May 7, 2010
NRC3-10-0018

References: 1) Fermi 3
Docket No. 52-033
2) Letter from Ilka T. Berrios (USNRC) to Jack M. Davis (Detroit Edison),
"Request for Additional Information Letter No. 28 Related to the SRP Sections
2.4 and 3.7 for the Fermi 3 Combined License Application," dated March 26,
2010

Subject: Detroit Edison Company Response to NRC Request for Additional Information
Letter No. 28

Figure 2.4-212 Lake Erie Extreme Water Levels (1970-2007) NAVD 88 [EF3 COL 2.0-13-A]

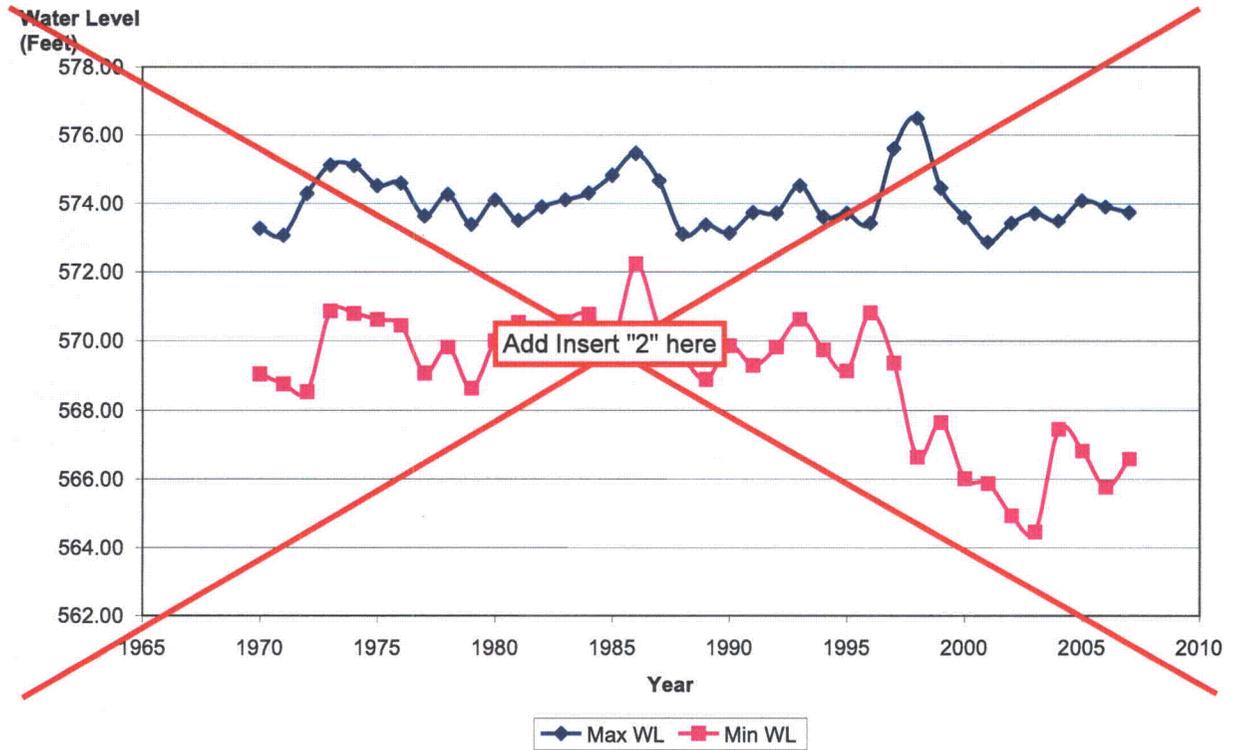
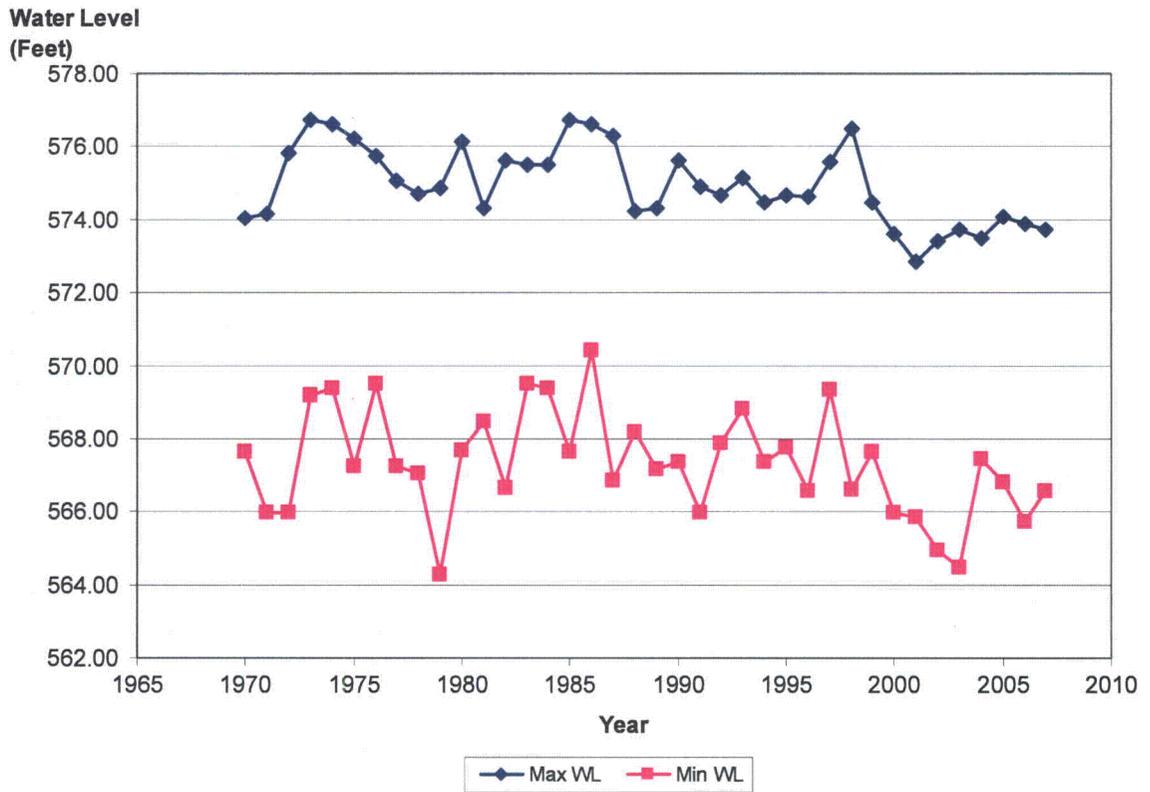
To meet the requirements of 100.20(c) and 52.79(a)(1)(iii), the NRC staff request that the applicant provide an update to information provided in the FSAR. All Lake Erie hourly lake-level data that were used to calculate the 100-year lake level were provided in an excel spreadsheet as a response to RAI 2.4.5-1. The staff used the information to verify the values provided in FSAR Table 2.4-210. The staff identified errors in Table 2.4-210. For the years 1970 through 1996, the maximum values in Table 2.4-210 are lower than maximum hourly water levels contained in the excel spreadsheet, and the minimum values in Table 2.4-210 are higher than the minimum hourly water levels contained in the excel spreadsheet. The values presented for 1997 through 2007 were found to be correct by the staff (i.e., the values corresponded with values in the excel spreadsheet). The applicant should resolve the inconsistencies and provide updated information and tables.

The maximum and minimum water level values presented in FSAR Table 2.4-210 for the years 1970 through 1996 are based on the average daily value, whereas the maximum and minimum water level values presented for 1997 through 2007 are based on hourly recorded values. For consistency, FSAR Table 2.4-210 will be revised to show the maximum and minimum water level values based on hourly recorded values.

The proposed markups to FSAR Section 2.4.2.1, FSAR Table 2.4-210, and Figure 2.4-212 are attached. FSAR Section 2.4.2.1 refers to values in FSAR Table 2.4-210, and FSAR Figure 2.4-212 is a graphical representation of the information in FSAR Table 2.4-210. These markups reflect the revisions to FSAR Table 2.4-210.
